Date of Application: 4/19/2023

SUBJECT: Preliminary Site Plan and Design review for 40 Residential Units 2306 Fillmore Street.

PROPOSED 39 UNITS
MULTI-FAMILY
DEVELOPMENT FOR:
2306 FILLMORE STREET
HOLLYWOOD FL

DRAWING TITLE:
PAVEMENT
MARKING &
SIGNAGE PLAN

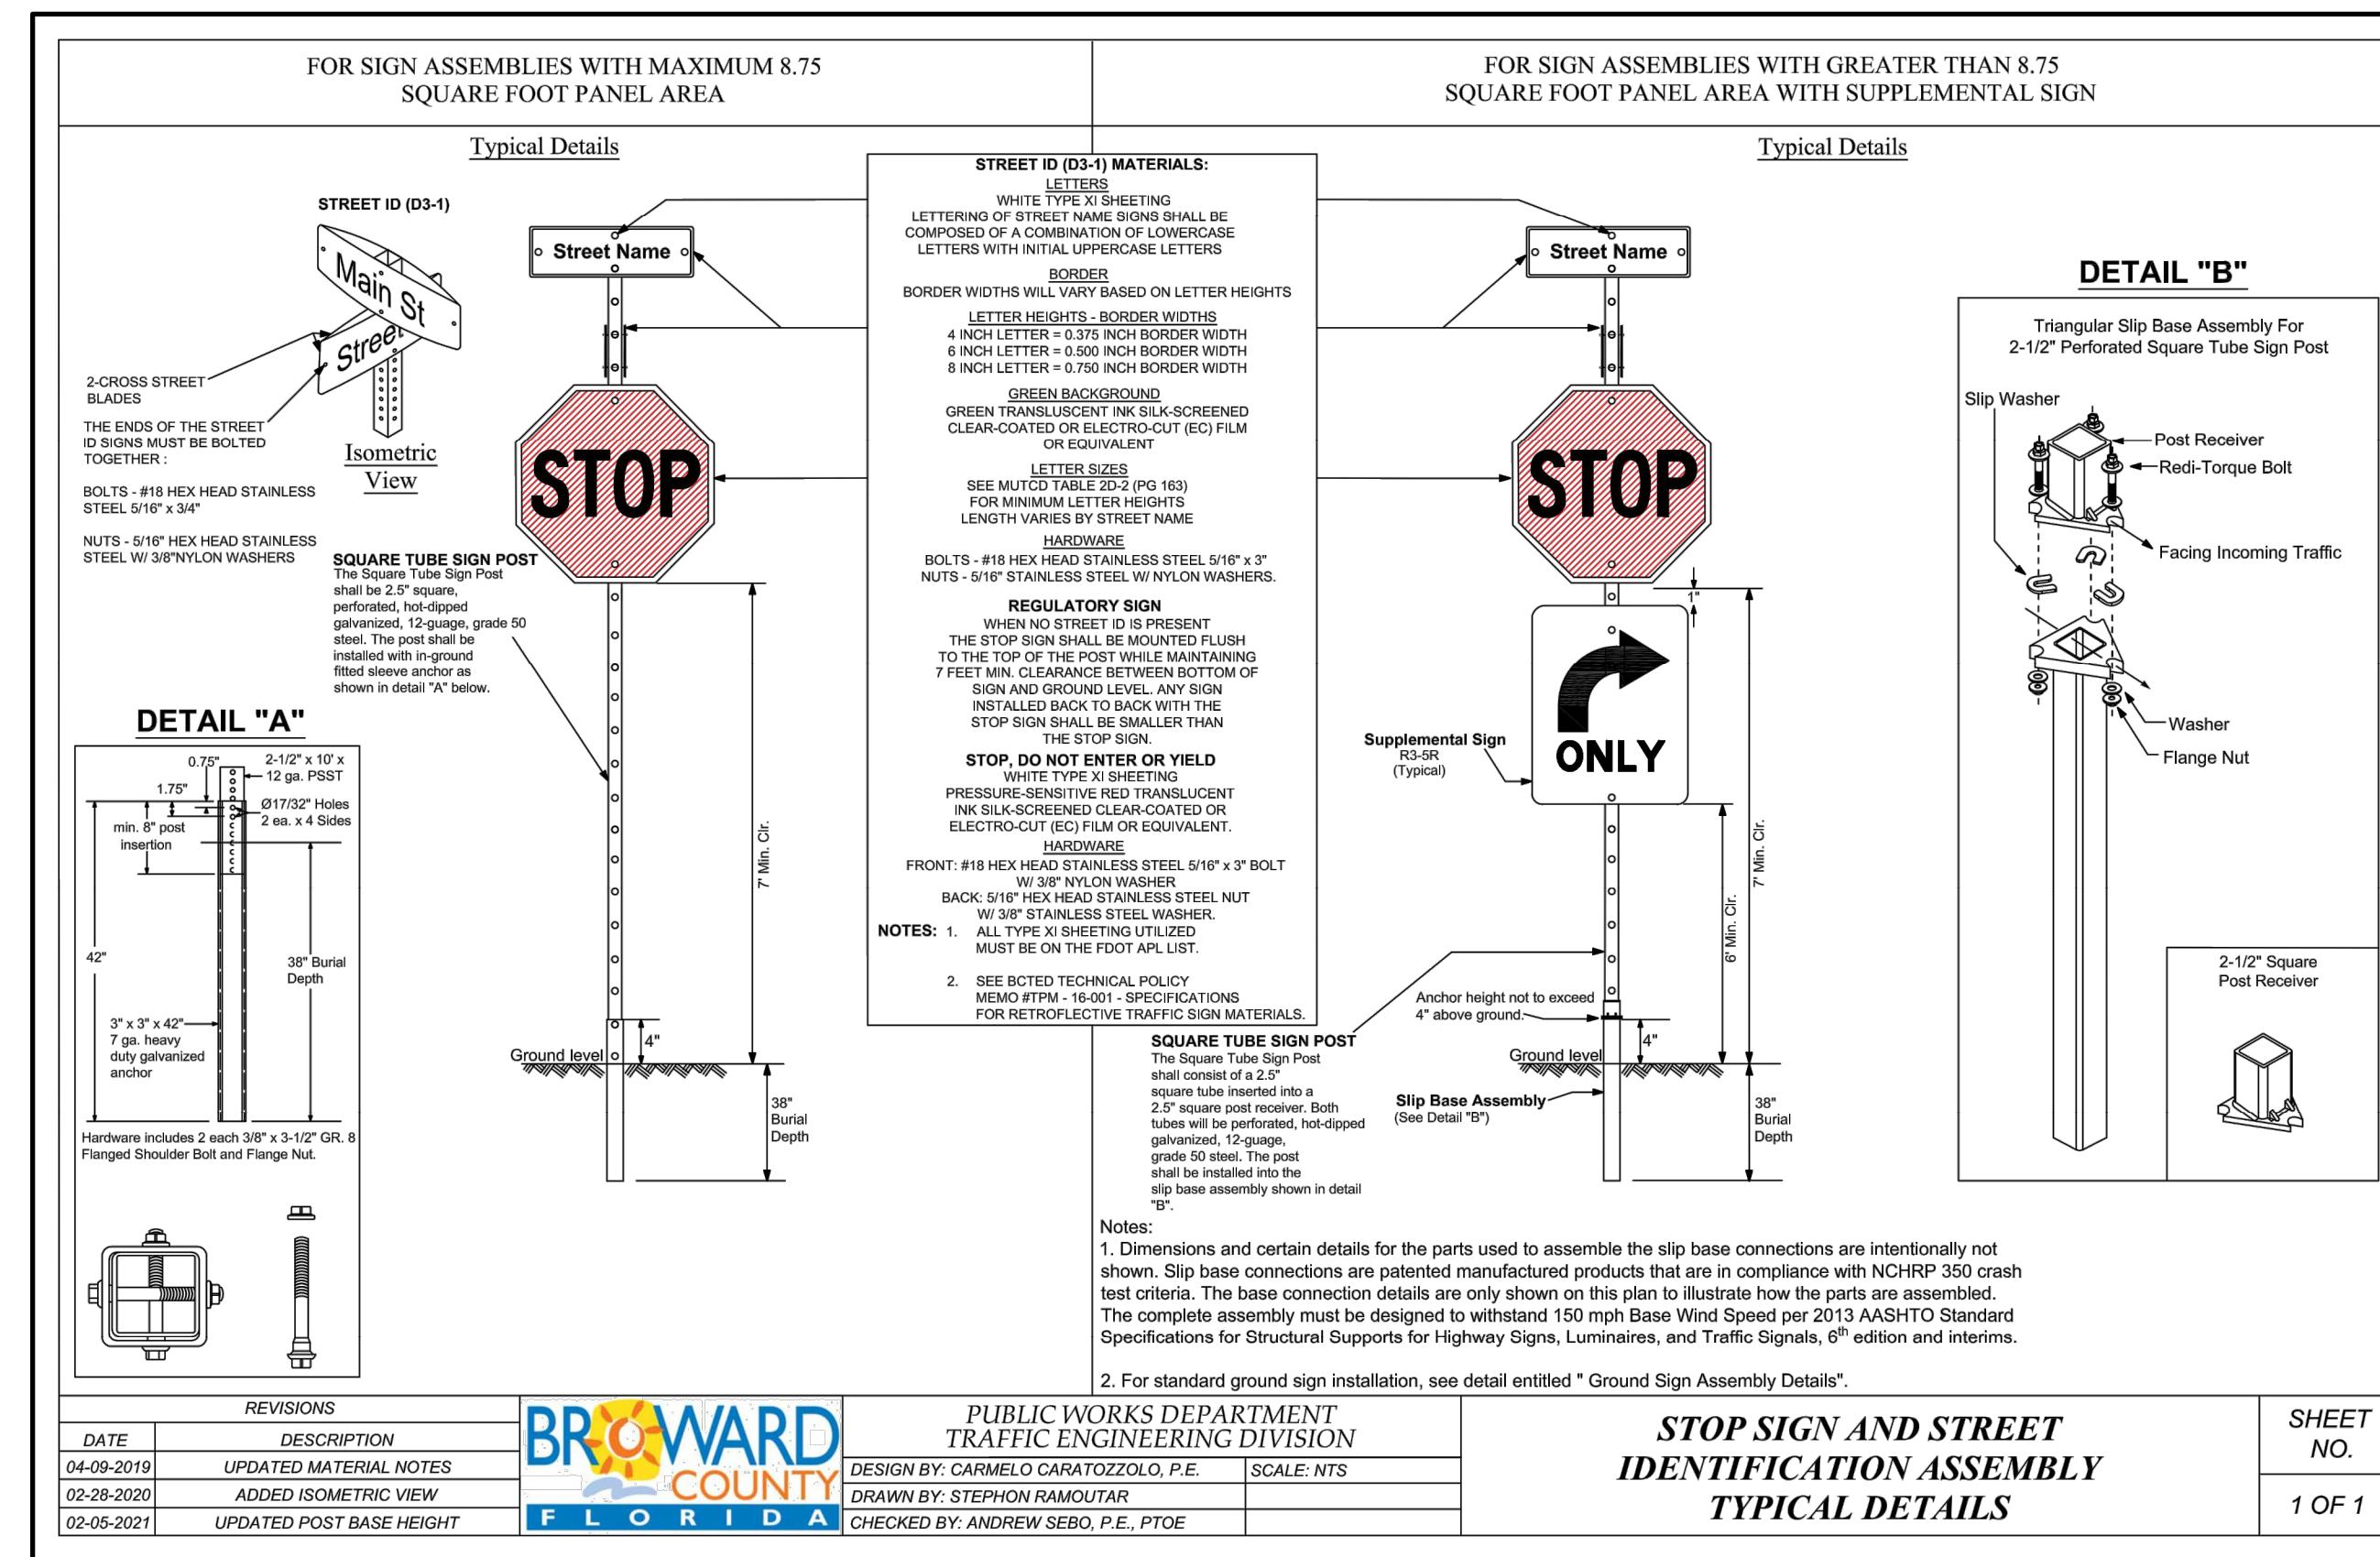
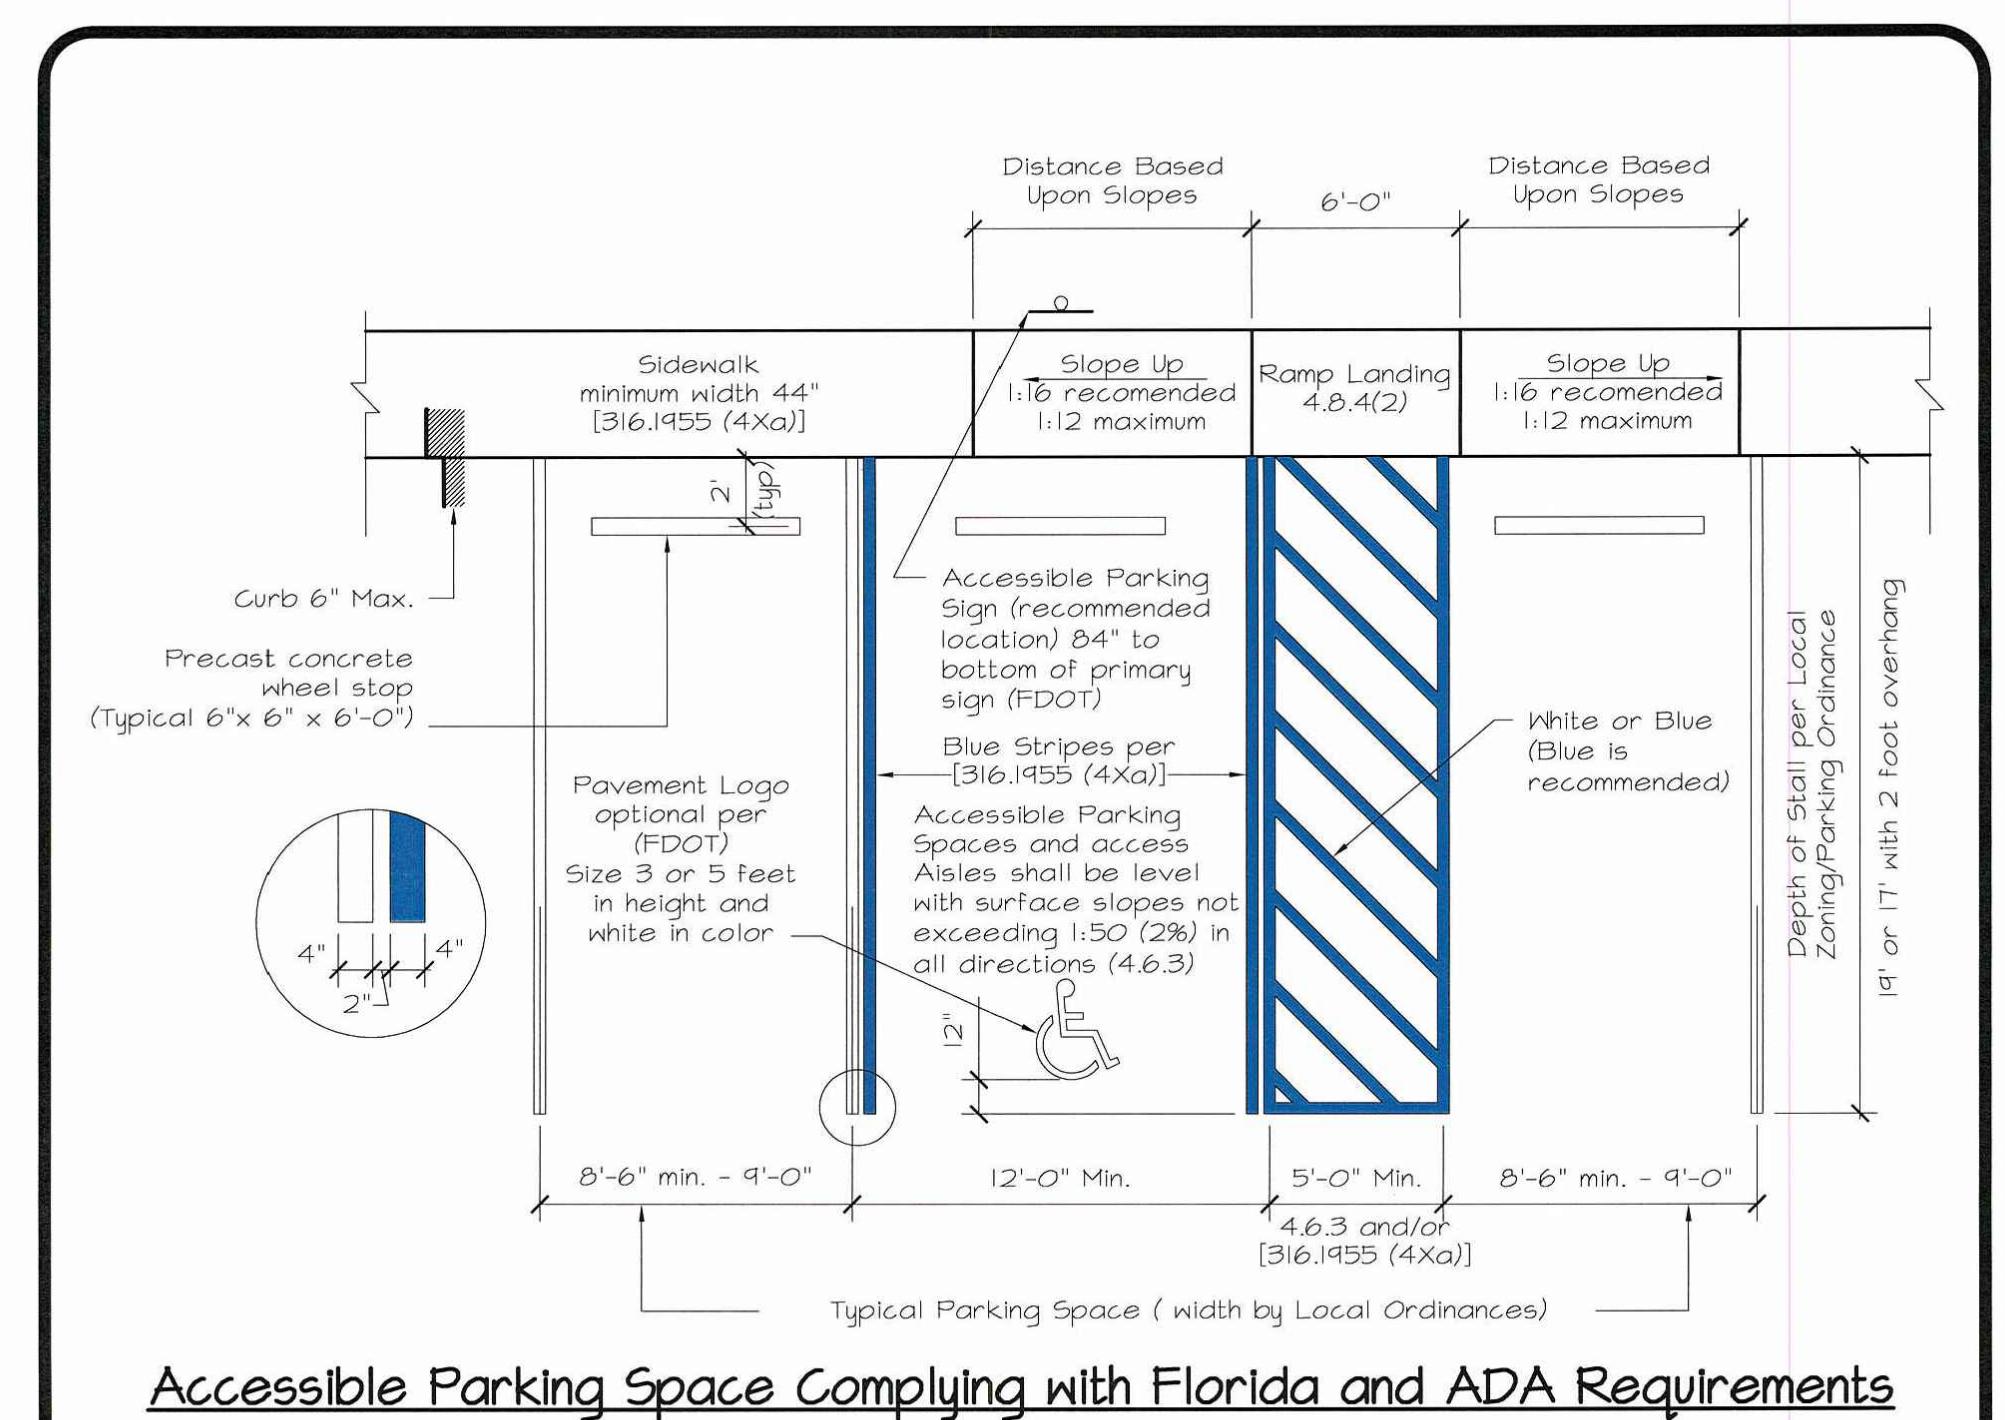
32. Please provide a pavement marking plan that is compliant with Broward County Traffic Engineering and City of Hollywood Standards. Provide any and all applicable standard sheets in the plan. (i.e. stop bars, do not enter signs, directional arrows, wrong way signs, parking stall stripping, ADA pavement markings etc.).

Response:Refer to sheet C-101 for Pavement marking & signage sheet.
